Service Engineering Operations
Customer Service Division

SUBJECT: NEW VEHICLE DELIVERY HOLD - Emissions Recall 25E05
Certain 2015 - 2018 Model Year Focus Vehicles with 1.0L Engine
Canister Purge Valve (CPV) Replacement (if required) and Powertrain Control
Module (PCM) Reprogramming

Emissions Recall 25E05

FIGURE 1

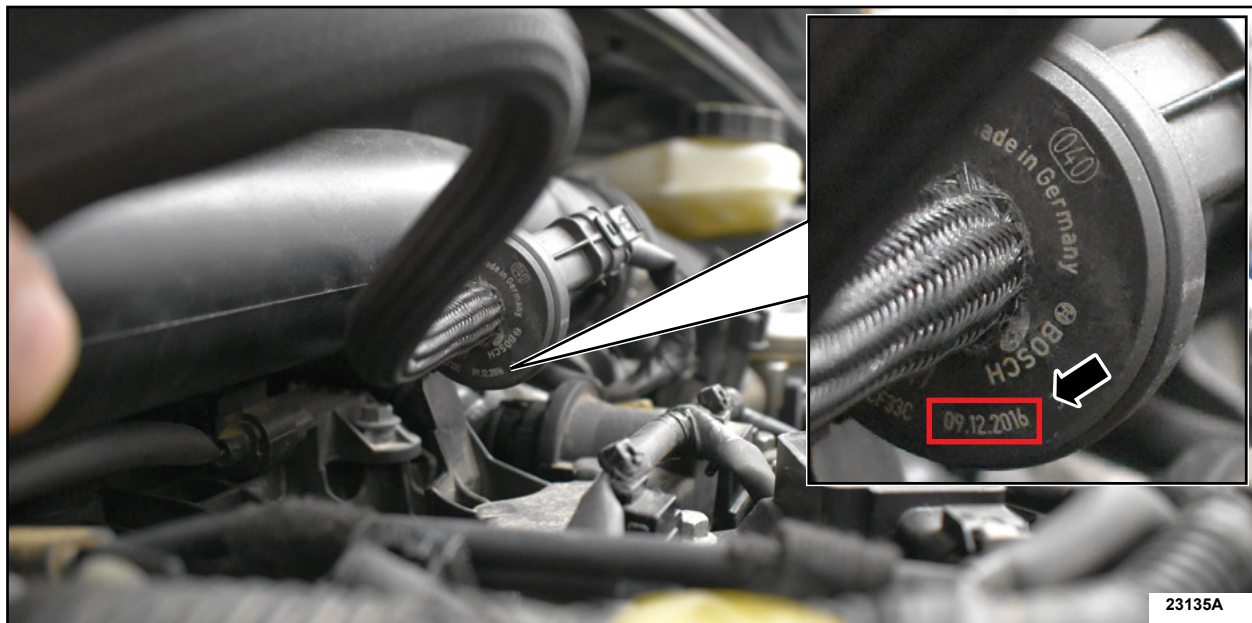
1. Inspect the evaporative emission canister purge valve for a date code as shown in Figure 1. The date code is read DD MM YY or DD MM YYYY.

- Is the date code readable and does it show the part was built on or after September 27, 2022 (27 09 22) or (27 09 2022)?

Yes - Perform only the Module Reprogramming and Software Verification steps on Page 2.

No - Replace the evaporative emission canister purge valve. Follow the Workshop Manual procedures in Section 303-13. Then, update the PCM software by following the Module Reprogramming and Software Verification steps on Page 2.
